Addendum No. 1

August 22, 2025

Re: Dells Pond Outlet Dam Improvements Project
Town of Littleton

From: DuBois & King, Inc.
Charles Johnston, P.E.
6 Green Tree Drive
South Burlington, Vermont 05403
(802) 878-7661

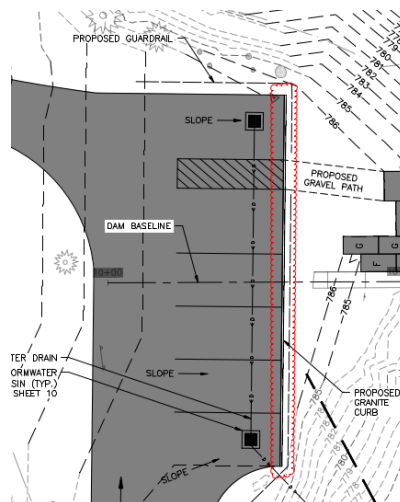
Question 4: Does the granite curbing go around the entire perimeter or just in front of the parking?

The granite curbing is only intended along the front of the parking to prevent stormwater from flowing on dam crest and down slopes. See Plan Sheet 7.
